**Re: Pio Pico Energy Center Project (11-AFC-01)**  
**Applicant's Response to Informal Data Request Related to Biological Resources**

**Pm PICO ENERGY CENTER PROJECT**

**SUPPLEMENTAL RESPONSES TO BIOLOGICAL RESOURCES DATA REQUESTS**

**REQUEST DATED AUGUST 31, 2011**

<b>EXHIBIT B</b>	
<b>MULTIPLE SPECIES CONSERVATION PROGRAM</b>	
PIO PICO ENERGY CENTER	
PROJECT NO.: 2418087	DATE: OCTOBER 2011
<b>URS</b>

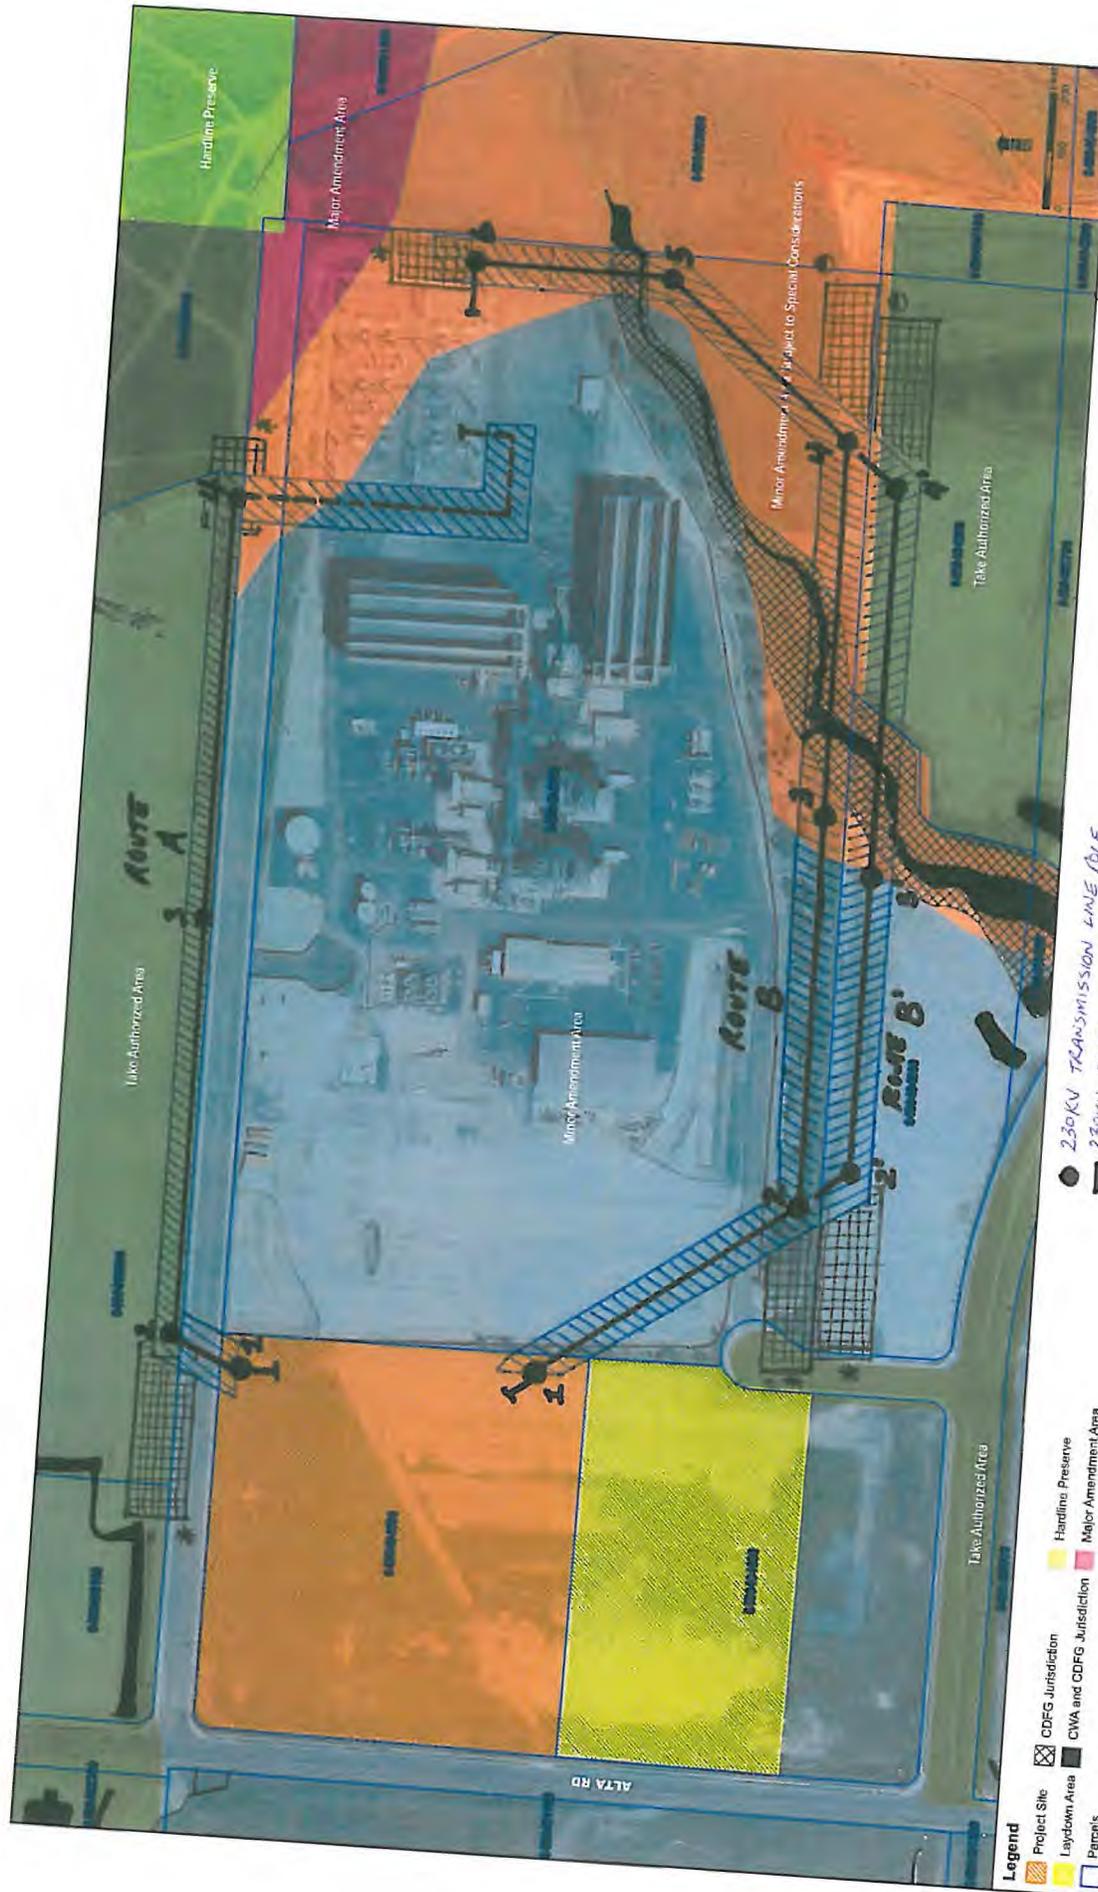
**Could you please provide clarification on where the Transmission Line Route B poles and right of way will be located in relation the MSCP designations on the attached map? Also, clarify if Route A was implemented instead where would it be located in relation to the MSCP designations? This map was provided by MSCP staff and the brown area is considered take authorized under MSCP, meaning it already went through the minor amendment process and impacts are allowed. The area in gray is a recorded biological open space according to the Parcel Map 20473, if impacts are proposed within that area it would require an open space vacation.**

**Please provide specific information regarding where the poles will be located as it relates to the MSCP designations on the attached map, how and where they will be accessed for installation and maintenance, including any access roads whether temporary or permanent, where any staging areas will be located, and where the 80 foot right-of way is proposed.**

Please refer to the attached map (Exhibit B<sup>1</sup>) for the proposed locations of transmission line structures A, B and B'. All three routes are located within either a Take Authorized area, a Minor Amendment Area or a Minor Amendment Area with Special Considerations, Specifically to Route A - if route A is implemented it would be located within a Take Authorized area, a Minor Amendment Area or a Minor Amendment Area with Special Considerations. Impacts to Minor Amendment areas must be processed by the County, which include paying a fee that will then be applied to the purchase of off-site mitigation lands. The Minor Amendment Areas with Special Considerations are transitional areas located primarily between the Major and Minor Amendment Areas where the likelihood of the presence of biologically sensitive resources is higher. The process for a Minor Amendment Area with Special Considerations is similar to Minor Amendment Area, but depending on the results of the biological resources report, on-site preservation may be required if particularly sensitive species are identified.

The existing vegetation communities identified during the biological surveys for in the Minor Amendment Area with Special Considerations include developed/disturbed, non-native grasslands and riparian vegetation. The developed/disturbed and non-native grasslands include no suitable habitat for special status species and have varying levels of anthropogenic disturbance. The riparian area is located within the drainage identified on the attached Exhibit (Exhibit B). Regardless of which transmission line structure option is selected (e.g., transmission line structures A, B or B'), installation will not result in temporary

and/or permanent impacts to the riparian area because the drainage will be avoided. The transmission line structures design was located and intended to avoid special aquatic resource areas within the region. Furthermore, Mitigation Measure B10-8 includes placement of a temporary Environmentally Sensitive Area (ESA) fence around the drainage to minimize habitat disturbance. Therefore, on-site preservation is not expected to be required.
